HI-STORM 100 CERTIFICATE OF COMPLIANCE 72-1014

LICENSE AMENDMENT REQUEST 1014-1

April 25, 2000

Subject: Holtec Proprietary Information

Figure 2.1.4; BWR Axial Burnup Profile with Normalized Distribution

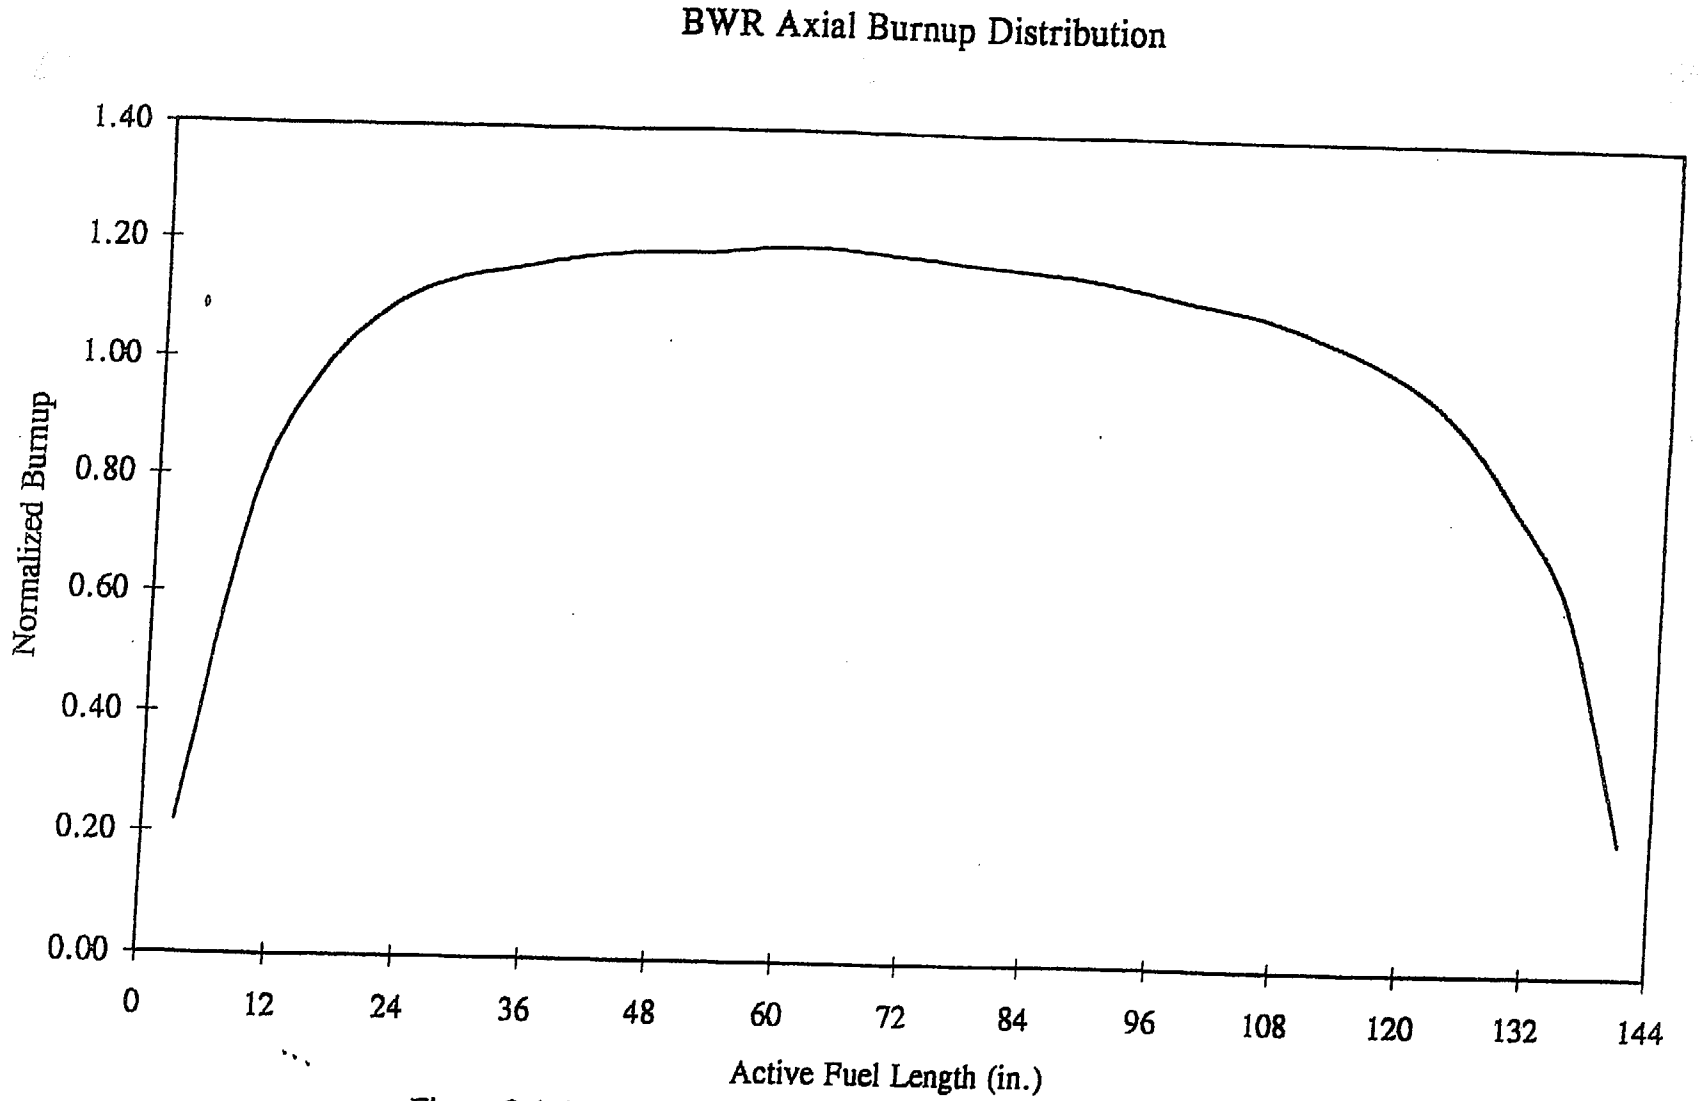
z. Figures 2.1.3 and 2.1.4 are revised to delete the proprietary note in the footer.
